UNITED STATES PATENT AND TRADEMARK OFFICE

| Office Action Summary | Application No. 10/747,848 | Applicant(s) TSENG ET AL. | |

DETAILED ACTION

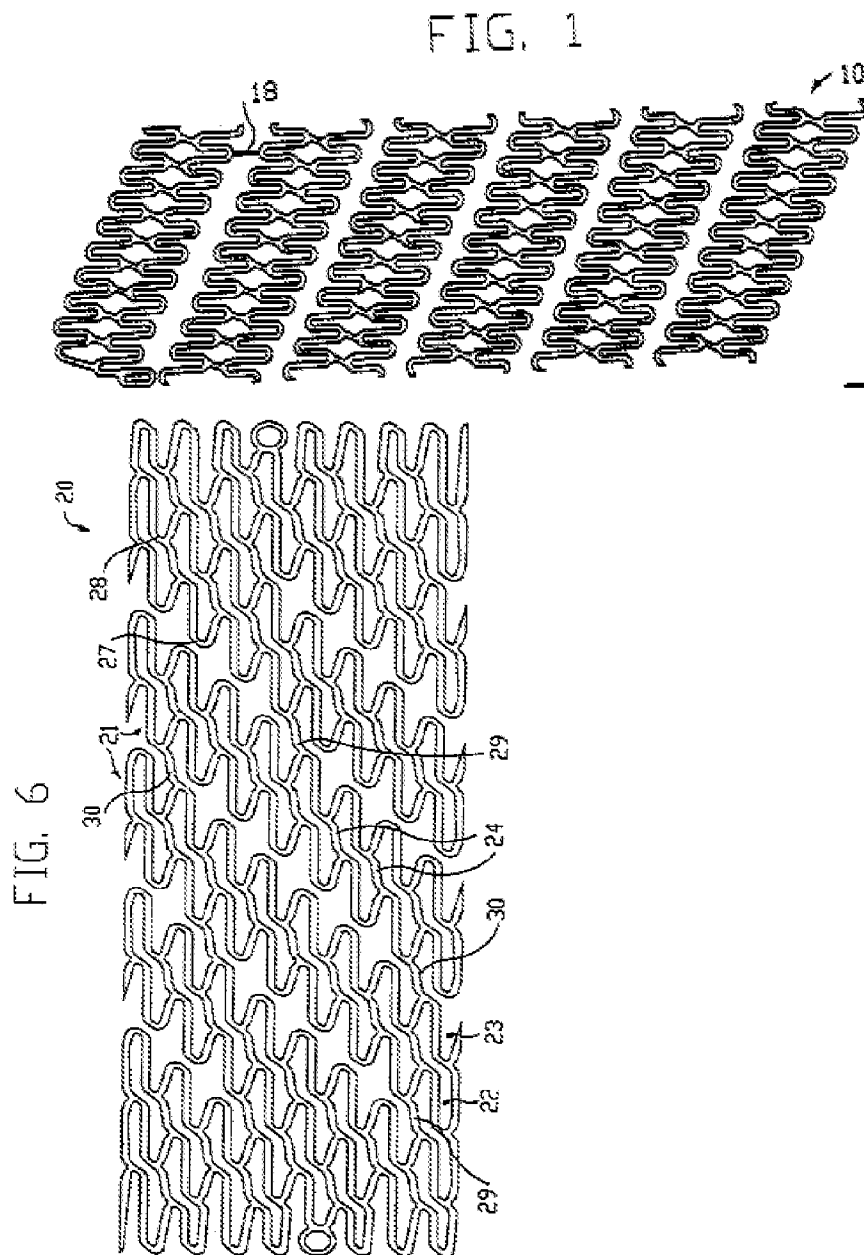
Re claims 1, 6, 8, 15, 22, 24 and 32, Kanesaka teaches an intraluminal stent comprising a plurality of hoops disposed in helical succession, clearly seen in figs. 6 and 1 recreated here, each of said hoops defined by a single continuous filament that

defines a helical arrangement of elements defined by a successive series of substantially straight struts, again, clearly shown in figs. 1 and 6, elements 21, connected by apex sections, elements 27, alternately pointing in opposite axial directions, even more clearly defined in fig. 1., at least one connecting member 18 or 29 which can be adapted to do anything; a direct connection, where 19 or 29 are directly connected to the stent area struts, and a separate bridging member actual length of element 18 or 29. Hoops are seen in fig. 6 as are end hoops, which have elements that are perpendicular to the circumference and parallel to the axis of the stent.
